GROUP	MODEL
ELE	2022MY K5 (DL3a) w/o Smart Cruise
NUMBER	DATE
260 (Rev 1, 01/04/2023)	August 2022

TECHNICAL SERVICE BULLETIN

SUBJECT: **SERVICE ACTION: STEERING WHEEL REPLACEMENT
FOR INCORRECT BUTTONS (SA505)**

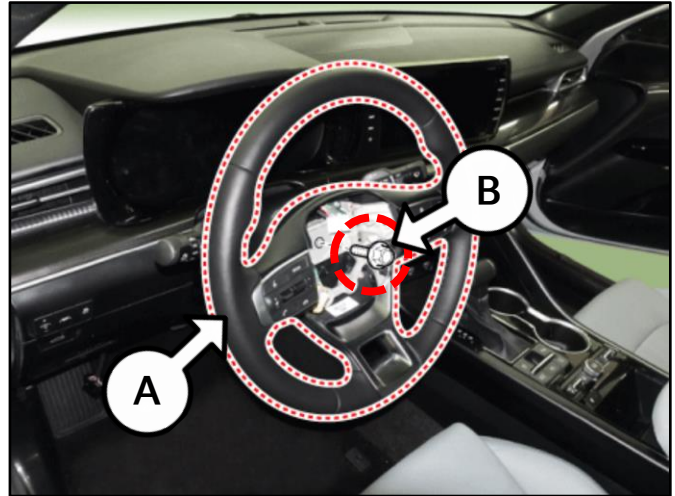
1. Replace the steering wheel (A) by referring to "Steering System → Steering Wheel → Repair procedures (Removal)" in the applicable Shop Manual on KGIS.

Tightening torque for Steering Wheel
Lock Bolt (B):
28.9 - 36.2 lb.ft (39.2 - 49.0 N.m)

The steering wheel lock bolt (B)
CANNOT be reused. Install a new bolt.
